TECHNICAL MEMORANDUM

Prepared by: Tom Myers, Ph.D., Hydrologic Consultant, Reno NV

Re: Review of Phase 2 Ground-Water Investigation Report for the San Mateo Creek Basin Legacy Uranium Mines Site

Figure 1: North-south hydrogeologic cross-section along the San Mateo Wash. The cross-section shows the Homestake Mill on the left (southern portion of the cross-section) and the confluence of the Arroyo del Puerto and upper San Mateo Creek on the north. Source: Figure A2-3 from EPA (2018)

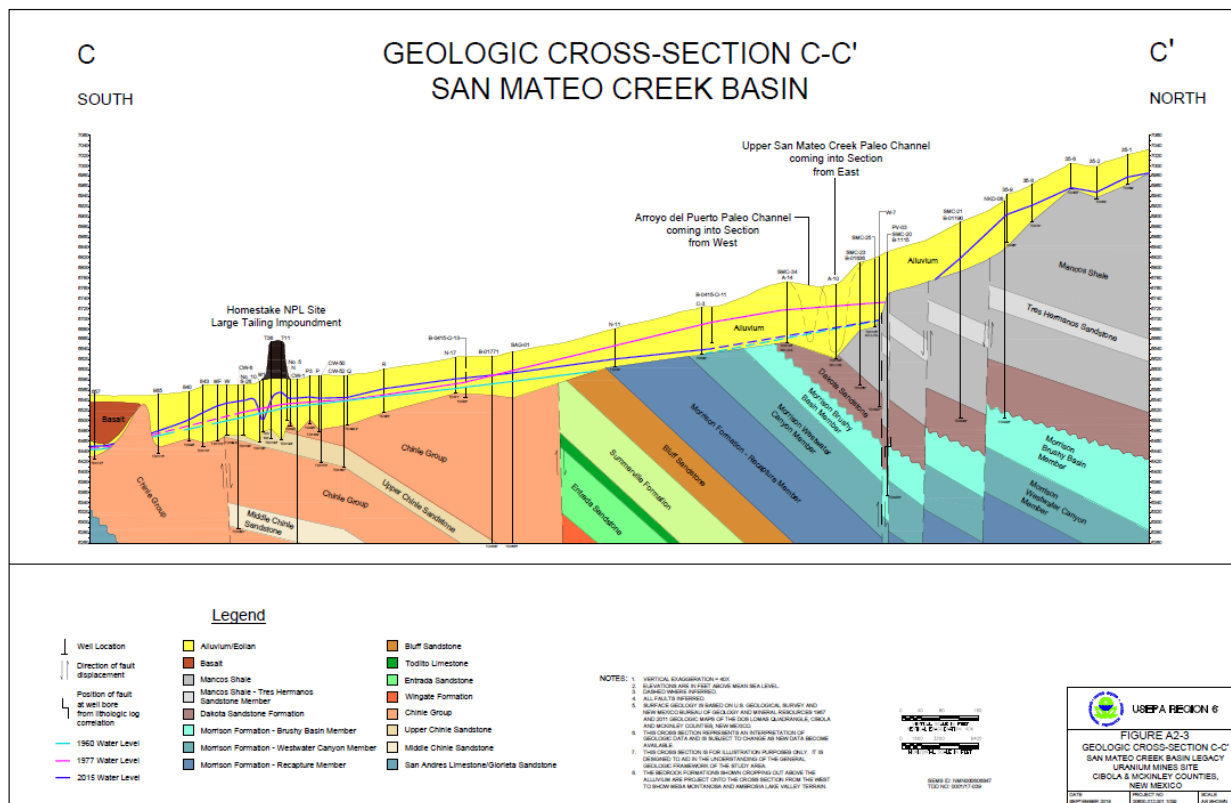
The hydrogeologic cross-section along the San Mateo Wash indicates the primary pathway for water from the Ambrosia Lake area to mix with groundwater near the Homestake Mill, including in the Chinle and alluvial formations, is through surface water or through the alluvium (Figure 1). The downward dip of the formations north of the Chinle would not be conducive for bedrock flow anywhere other than into the alluvium if there is enough head in the bedrock. The fault between the Chinle and other

bedrock formations might inhibit downgradient flow from the Upper Basin, even if the fault enhances vertical flow at the fault contact. The San Mateo fault generally parallels and coincides with the section in Figure 1. The cross-section also shows water levels in 1975 much higher than in 1960 or at present. The report directly acknowledges that seepage from the Homestake mill recharged and contaminated the underlying Chinle water-bearing sandstone units where they subcrop to the alluvium (p A4-2).

Figure 3: Alluvial saturation shown in blue for the 1975 to 1977 period. Source EPA (2018) Figure A4-2

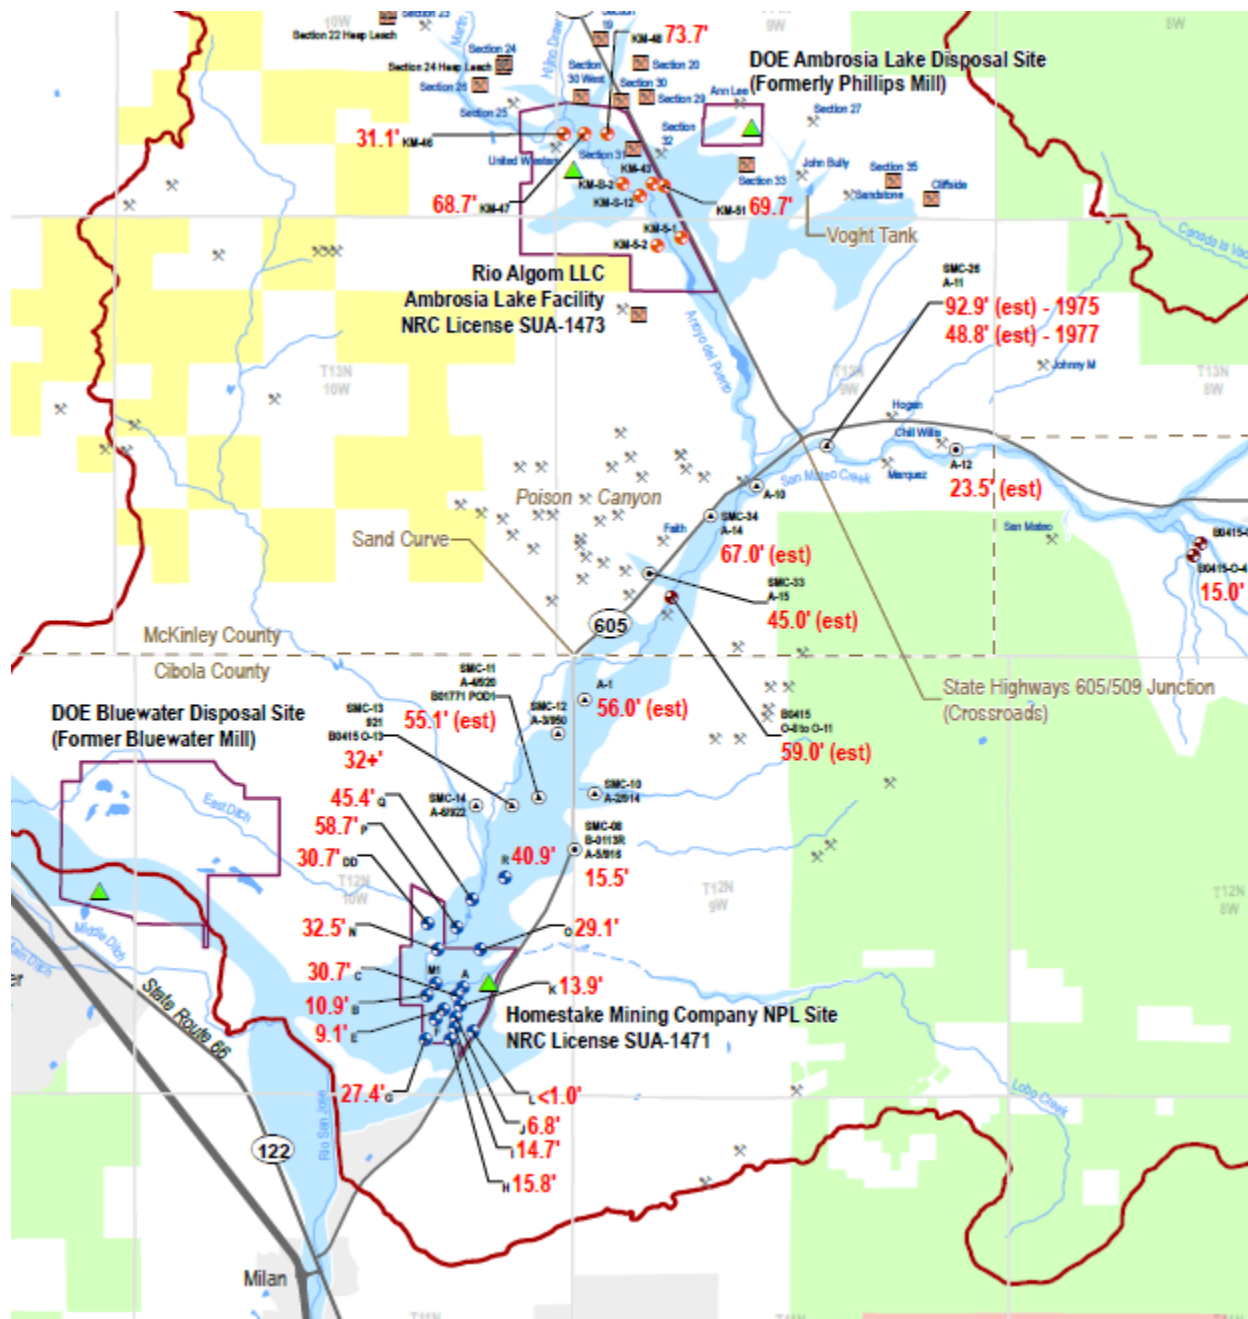
In the mid-1970s, saturation was extensive, with the most impressive increase in area being in the Ambrosia Basin which of course is where the mines were discharging water. The saturated area near the confluence, Sand Curve and Homestake Mill Site is constrained by the width of the paleo channel. One section between the confluence and Sand Curve expanded in the mid-1970s. The saturated thickness has increased substantially, from about 11 feet at Sand Curve in 1960 to 56 feet in the mid-1970s. Between the confluence and Sand Curve, the thickness in the mid-1970s ranges from the 50s to 60s feet.

The figures also indicate the saturated alluvium south of the LTP grew since 1960. The blue saturated area covered a smaller area southwest of the LTP in 1960 (Figure 2), than in the 1970s (Figure 3). The saturated thickness would also have increased commensurately. In this area, the millsite seepage was most responsible for increasing the saturation in the alluvium.

Figure 4: Alluvial saturation shown in blue for the 2015 to 2016 period. Source EPA (2018) Figure A4-3

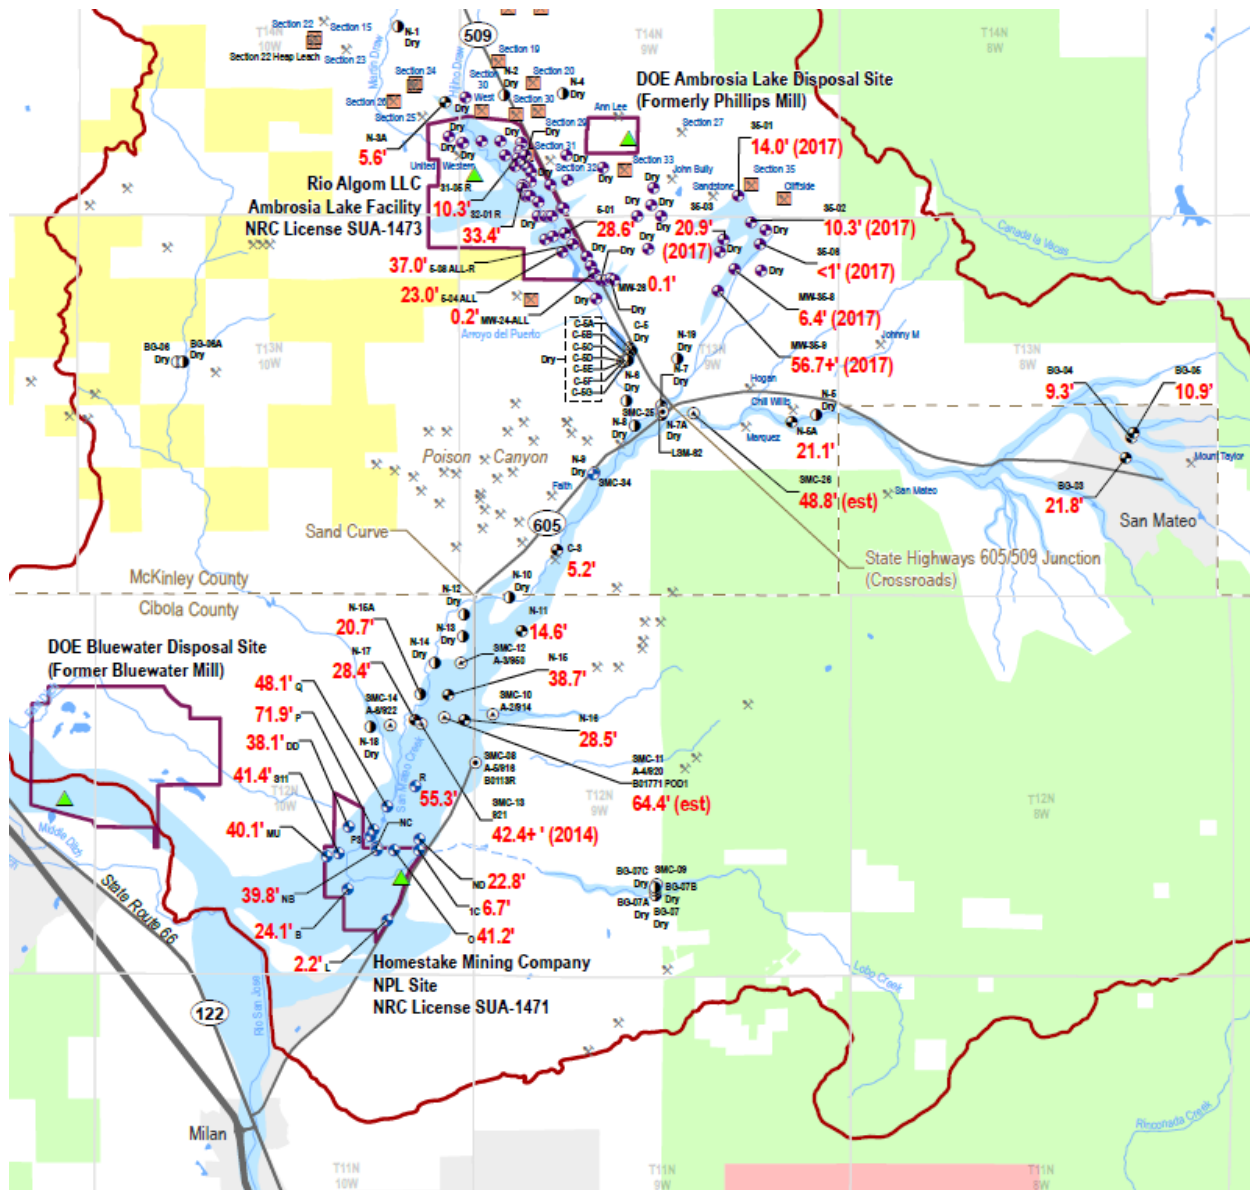
At present, there is substantial residual saturation in the Ambrosia Basin. The residual saturation in Ambrosia Basin probably reflects the underlying bedrock having a low conductivity and a bit of damming in the alluvium that prevents flow to the confluence. The very narrow saturated zone in the mid-1970s reflects this (Figure 3). Saturation has contracted substantially in the lower San Mateo basin to closely resemble the saturation in 1960 (Figure 2). It is notable that the saturated thickness is maximum at present at the Homestake Mill where the thicknesses range from the teens to over 40 feet, substantially more than during the mid-1970s. This is due to the ongoing injection/extraction activities at the millsite.

Figure 5: Alluvial groundwater elevation and spot changes between 1960 and 1975 in the lower San Mateo Basin. Source: EPA (2018) Figure A4-9

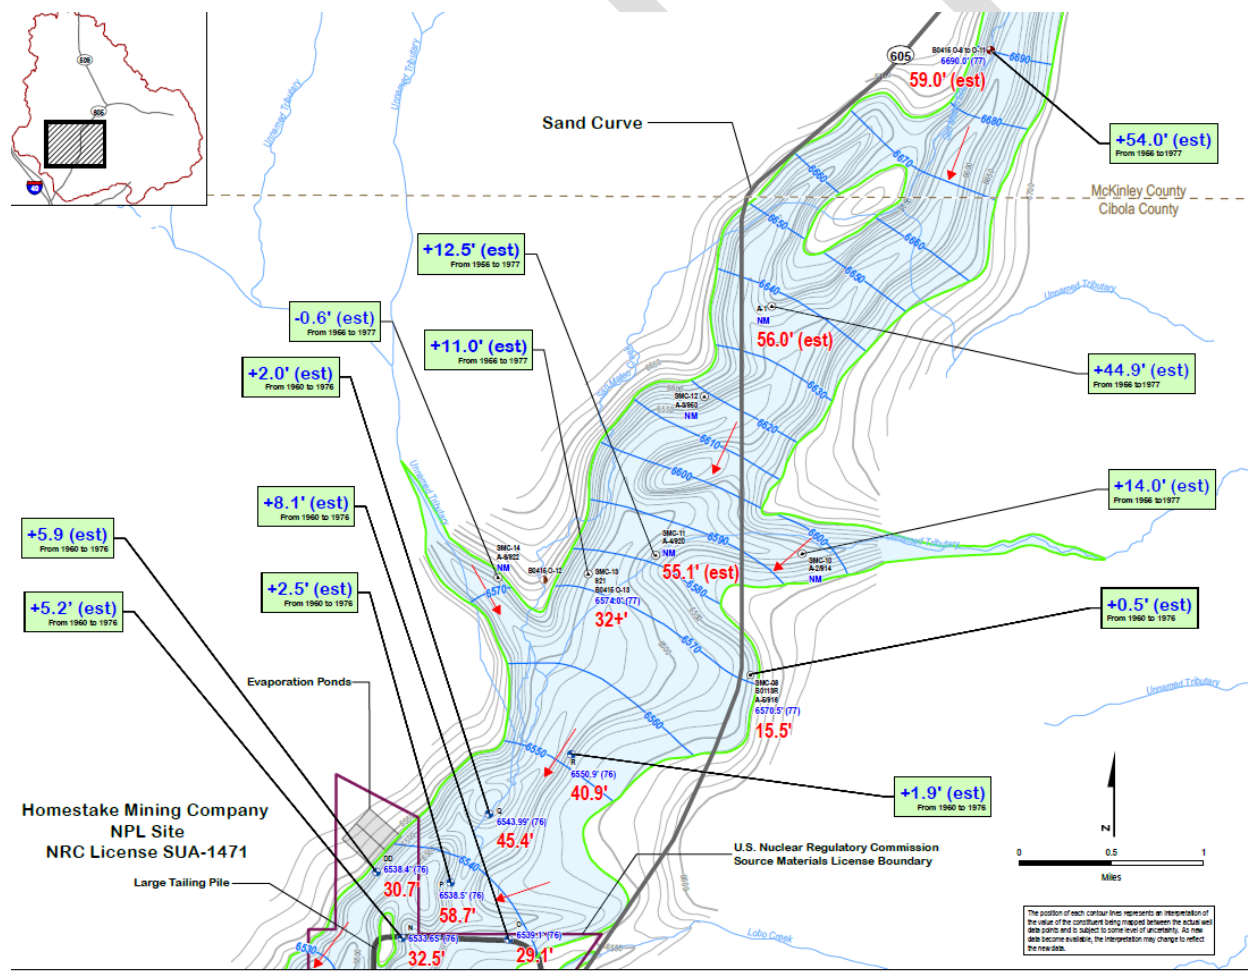
The groundwater level in the lower San Mateo Basin increased from 1960 to 1975 and the aquifer increased in width (Figure 5). Compared with Figure A4-8, groundwater levels increased from over 50 feet near the confluence to a couple feet between Sand Curve and the Homestake Millsite (the numbers in green boxes in Figure 5 show the change between 1960 and 1975). One reason the increase in groundwater table and saturated thickness is so much more upstream near the confluence could be the narrowness of the alluvial channel which causes the groundwater to pond in that area. It could also be that a wave in the groundwater was passing through the confluence and was only beginning to reach the channel near and south of Sand Curve. The report would have to include a series of maps through the 1980s to determine whether this explanation is possible.

Groundwater levels near the LTP have increased more than they increased further upstream even though there is no obvious difference in the alluvial channel area that would cause ponding at that

point. This increase near the LTP visible in 1975 could be the beginning of a mound forming beneath the LTP, as hypothesized by Myers (2015) as a means of a short-distance gradient reversal to cause U to move from the LTP seepage northeast against the general flow through the alluvium. The development of a mound would be easier to assess with a series of maps through the 1980s.

Figure 6: Alluvial groundwater elevation and spot changes between 1975 and 2016 in the lower San Mateo Basin. Source: EPA (2018) Figure A4-11

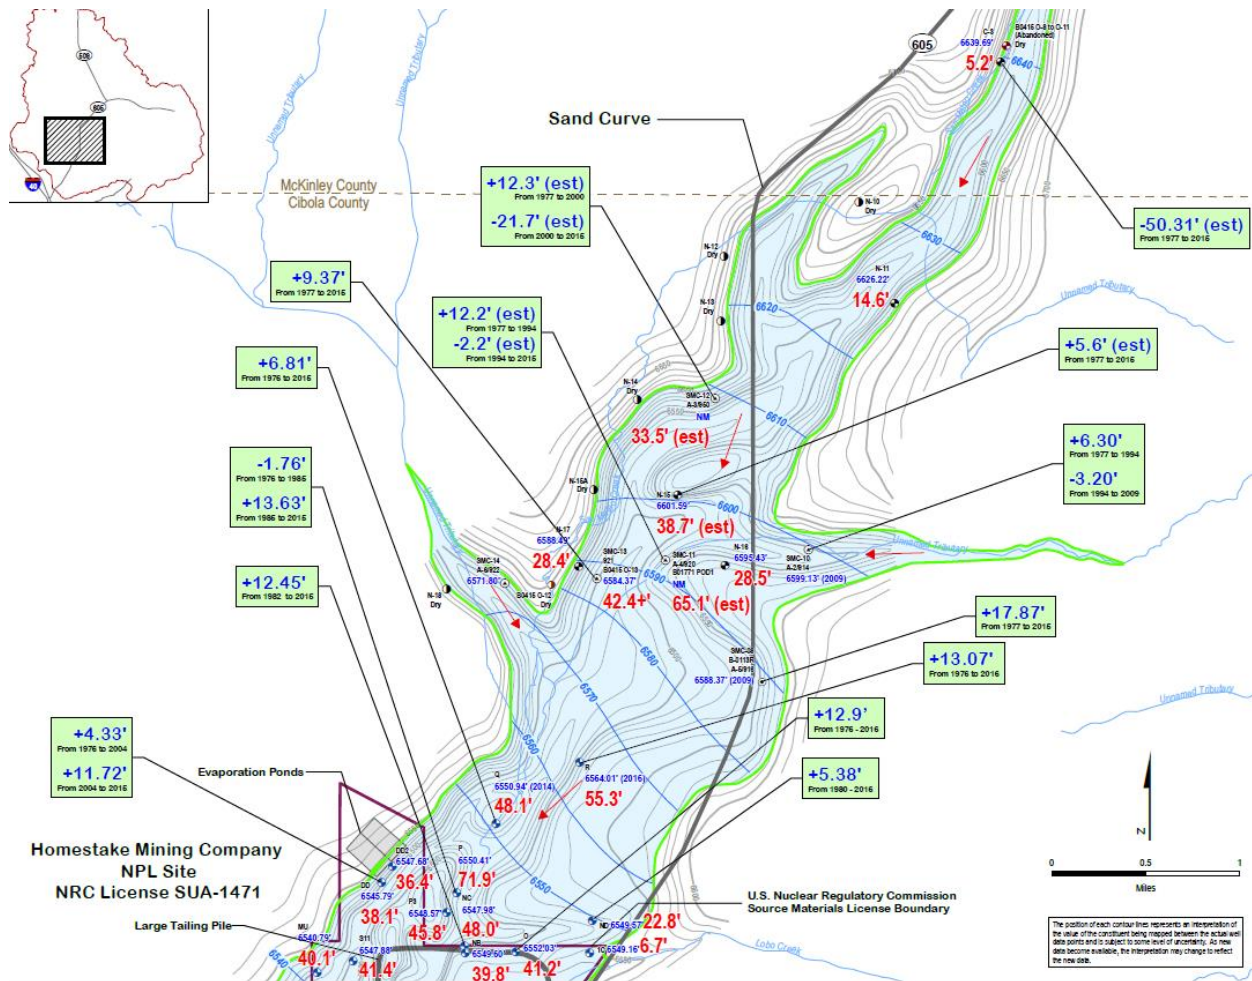
Groundwater elevations and the changes between 1975 and 2016 show the movement of a groundwater slug from the confluence through Sand Curve toward the LTP (Figure 6). Groundwater levels decreased over 50 feet at the point furthest north, in the confined bedrock channel (well C-3). Further south overall changes were much less although some wells show that a higher groundwater elevation was attained in the 1990s after which either a substantial decrease occurred (well SMC-12) or, further south, most increase occurred before the 1990s and since the decrease has been slight (wells SMC-11, SMC-10). Further south near the LTP, the increase has simply continued (where there were readings in the 1990s, more groundwater level increase has occurred since then). This effectively describes a slug moving through the alluvium in the bedrock channel, with the mounding under the LTP damming the groundwater flow. Although the alluvium has effectively desaturated from the Sand Curve to the north since the 1970s, the saturated thickness has increased since then south of Sand Curve.

Figure 7: Uranium concentrations in the alluvium of the Lower Basin. Source: EPA (2018), Figure A4-12.

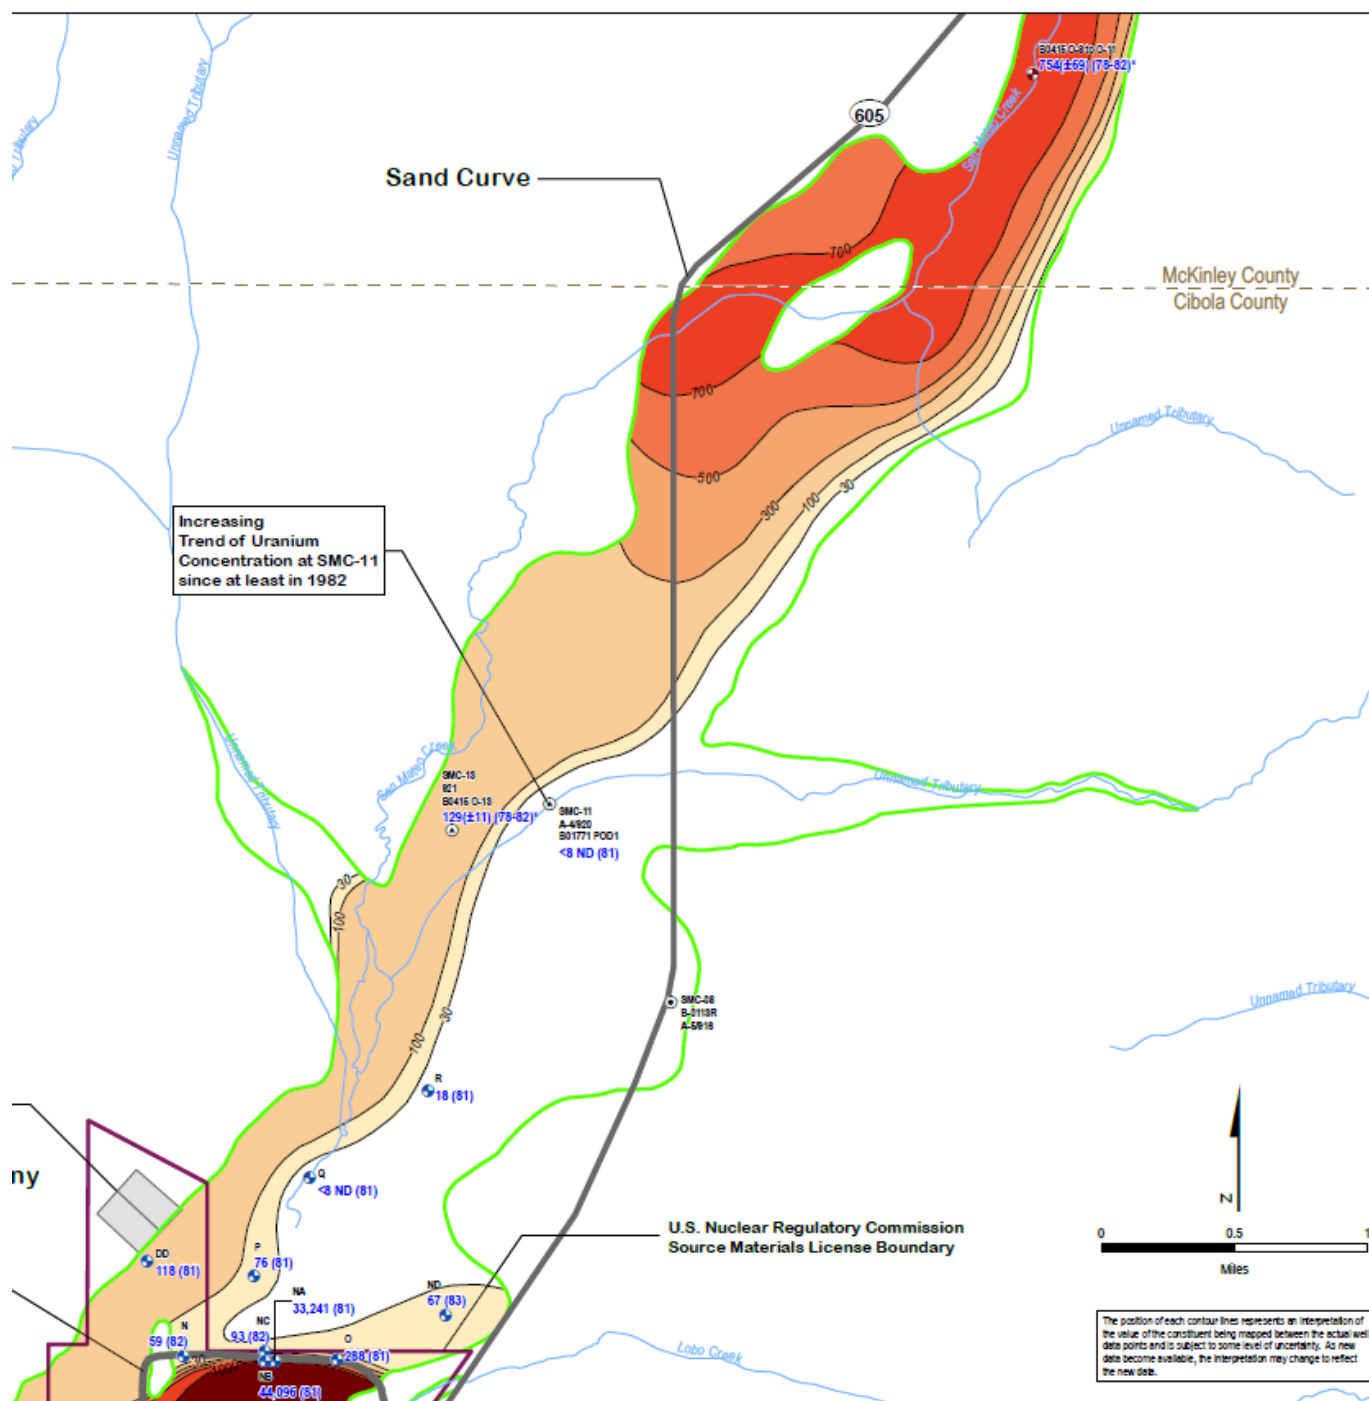
U plume maps for the 1970s and the mid-2010s show the movement of U downstream along the San Mateo Wash, showing the movement of a plume from the Crossroads area to near Sand Curve (Figures 7 and 8). However, the 1970s plot is based on too little data. There is only a cluster of observations averaging 0.754 mg/l; however, the 0.7 mg/l contour extends south along the channel particularly in the deeper paleochannel on the west side (Figure 7). The report notes the “elongated and narrow plume of higher uranium concentrations extending from the northern boundary of the map to the southern boundary of the map along the western margin of the SMC paleo-channel” (p A4-17). Because SMC-13 has U at 0.129 mg/l, there must be a gradation between the points, but the report cites no data to support drawing the 700 ug/l plume so far southwest along the paleo channel. However, the DD well in the paleochannel near northwest of the LTP has U at 118 ug/l while the concentrations nearer the LTP are much lower. This observation supports the concept of a plume moving southwest in the paleochannel.
